**CITY OF TEMPE
DEVELOPMENT REVIEW COMMISSION**

Meeting Date: 09/12/2017
Agenda Item: 3

ACTION: Request for a Development Plan Review consisting of a new restaurant for 2100 RIO RETAIL located at 2108 E Rio Salado Parkway. The applicant is Butler Design Group.

2100 RIO RETAIL Development Plan Review (PL170197)

SITE PLAN
 SCALE: 1" = 30'-0"

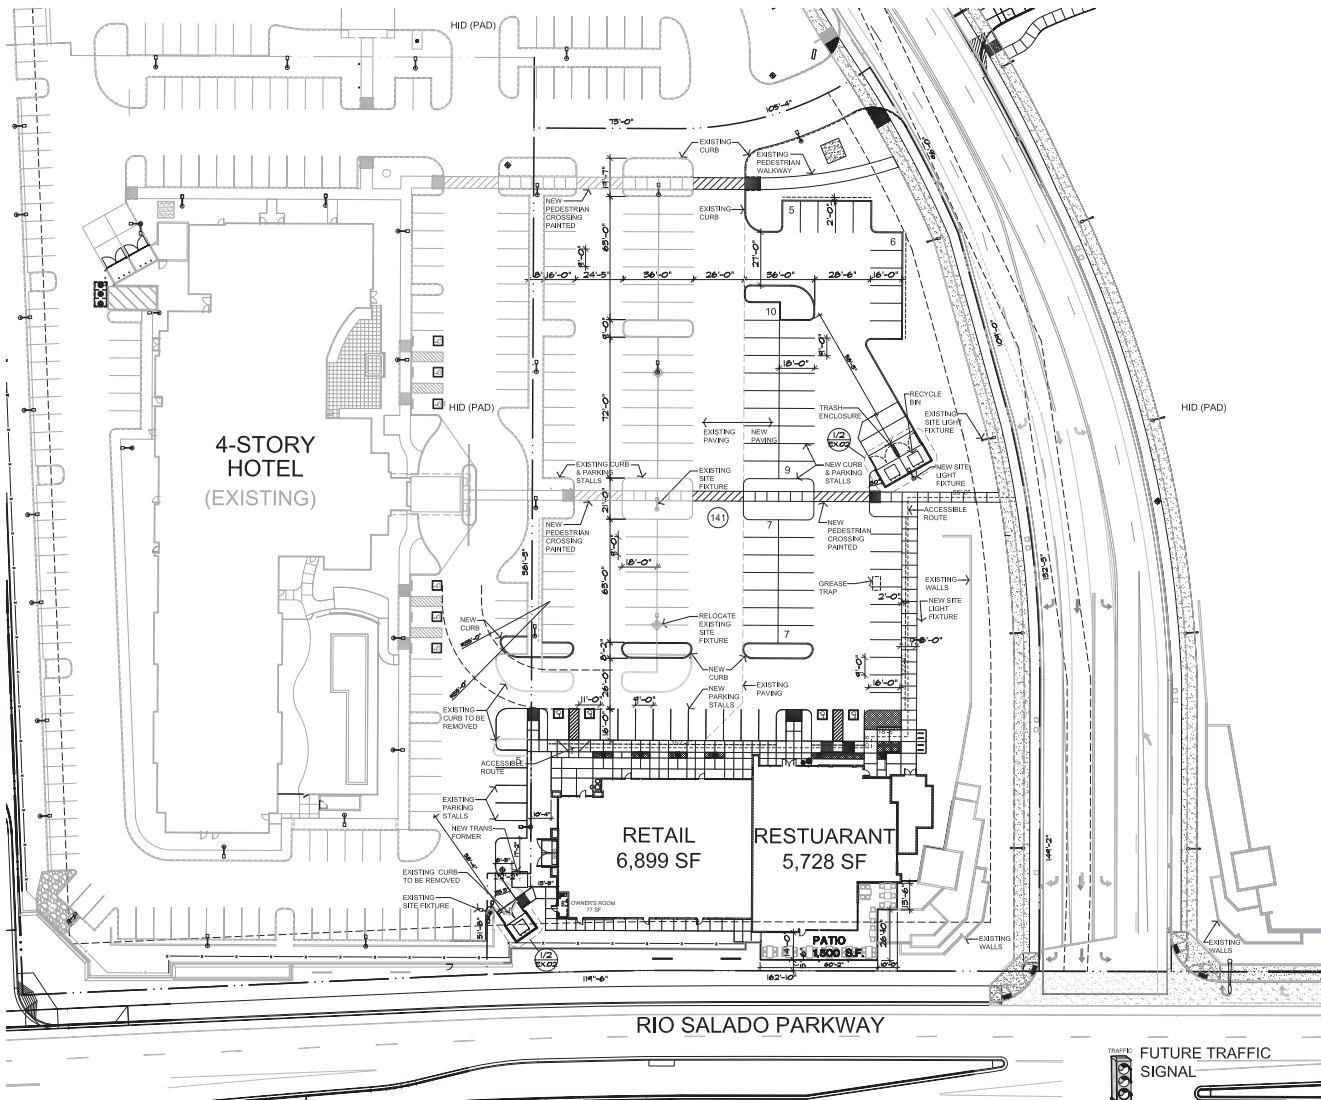
3. Provide service yard and mechanical yard walls that are at least 8'-0" tall as measured from adjacent grade and are at least the height of the equipment being enclosed, whichever is greater. Verify height of equipment and mounting base to ensure that wall height is adequate to fully screen the equipment.
4. Provide gates of steel vertical picket, steel mesh, steel panel or similar construction. Where a gate has a screen function and is completely opaque, provide vision portals for visual surveillance. Provide gates of height that match that of the adjacent enclosure walls. Review gate hardware with Building Safety and Fire staff and design gate to resolve lock and emergency ingress/egress features that may be required.

5. Utility equipment boxes for this development shall be finished in a neutral color (subject to utility provider approval) that compliments the coloring of the buildings.
6. Place exterior, freestanding reduced pressure and double check backflow assemblies in pre-manufactured, pre-finished, lockable cages (one assembly per cage). If backflow prevention or similar device is for a 3" or greater water line, delete cage and provide a masonry or concrete screen wall following the requirements of Standard Detail T-214.

PRELIMINARY LANDSCAPE PLAN

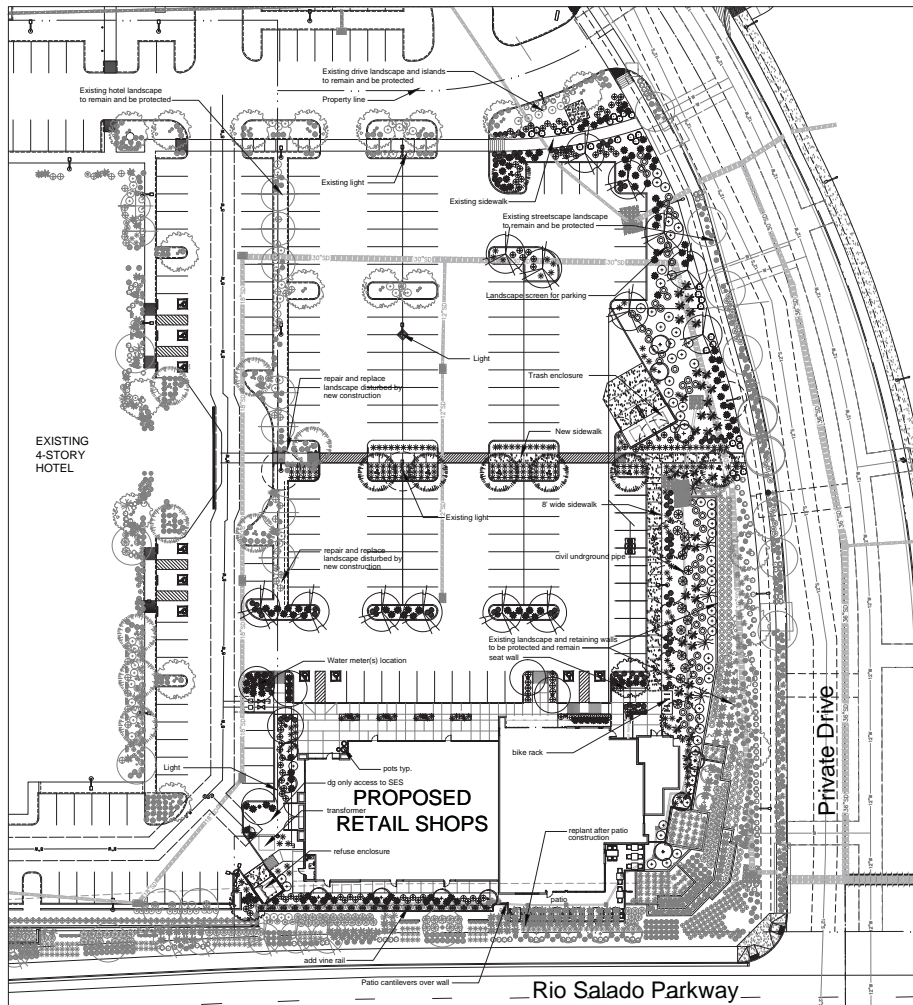
- a. Provide dedicated landscape water meter.
- b. Provide pipe distribution system of buried rigid (polyvinylchloride), not flexible (polyethylene). Use of schedule 40 PVC mainline and class 315 PVC ½" feeder line is acceptable. Class 200 PVC feeder line may be used for sizes greater than ½". Provide details of water distribution system.

- c. Locate valve controller in a vandal resistant housing.
- d. Hardwire power source to controller (a receptacle connection is not allowed).
- e. Controller valve wire conduit may be exposed if the controller remains in the mechanical yard.

- f. Repair existing irrigation system (on site or in the adjacent public right of ways) where damaged by work of this project. Provide temporary irrigation to existing landscape for period of time that irrigation system is out of repair. Design irrigation so that existing plants are irrigated as part of the reconfigured system at the conclusion of this construction.

16. Include requirement to de-compact soil in planting areas on site and in public right of way and remove construction debris from planting areas prior to landscape installation.

17. Top dress planting areas with a rock or decomposed granite application. Provide rock or decomposed granite of 2" uniform thickness. Provide pre-emergence weed control application and do not underlay rock or decomposed granite application with plastic.

1. DE-COMPACT SOIL IN ALL PLANTING AREAS ON-SITE AND IN PUBLIC ROW AND REMOVE ANY CONSTRUCTION DEBRIS FROM PLANTING AREAS PRIOR TO LANDSCAPE INSTALLATION.

2. TOP DRESS PLANTING AREAS WITH DECOMPOSED GRANITE APPLICATION. PROVIDE DG IN UNIFORM 2" THICKNESS. PROVIDE PRE-EMERGENCE WEED CONTROL APPLICATION AND DO NOT UNDERLAY ROCK OR DG APPLICATIONS W/ PLASTIC. PROVIDE CERTIFICATE OF PRE-EMERGENCE TO OWNER UPON COMPLETION.

1 SOUTH ELEVATION
SCALE: 3/32" = 1'-0"

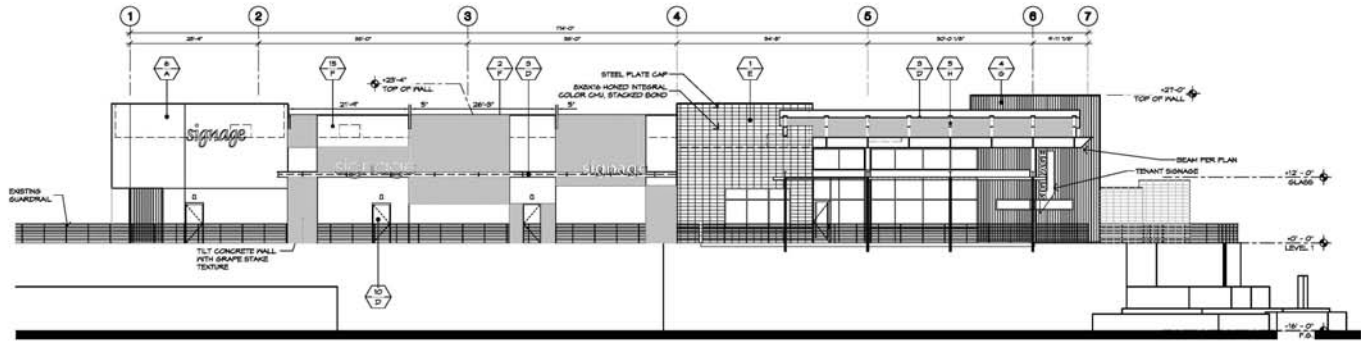
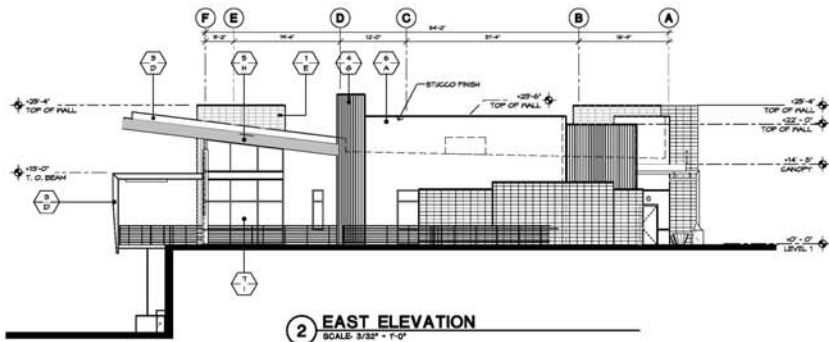
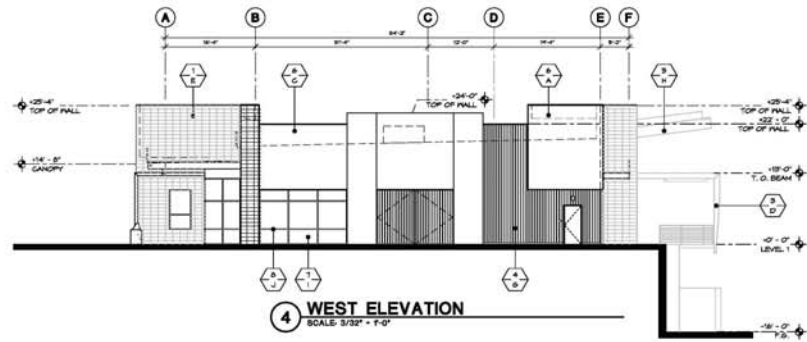
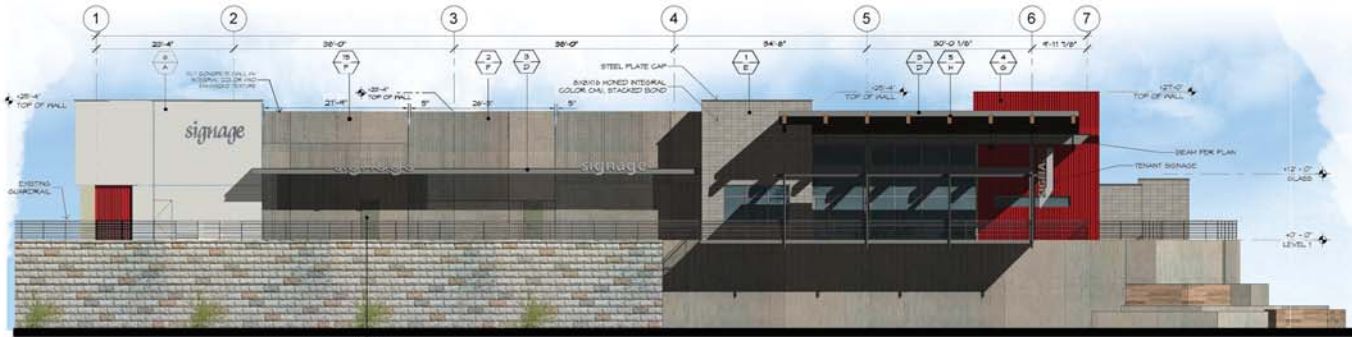
9. Provide secure roof access from the interior of the building. Do not expose roof access to public view.
10. Conceal roof drainage system within the interior of the building. Minimize visible, external features, such as overflows, and where needed design these to enhance the architecture of the building and coordinate with landscape plan for use of water, and with sidewalk plan to prevent spillways above or across walkways.

11. Incorporate lighting, address signs, and incidental equipment attachments (alarm klaxons, security cameras, etc.) where exposed into the design of the building elevations. Exposed conduit, piping, or related materials is not permitted.

12. Locate the electrical service entrance section (S.E.S.) as an integrated element of the west building wall that is concealed from public view.
13. Upper/lower divided glazing panels in exterior windows at grade level, where lower glass panes are part of a divided pane glass curtain-wall system, shall be permitted only if laminated glazing at these locations is provided.

18. Provide address numerals on all four building elevations.
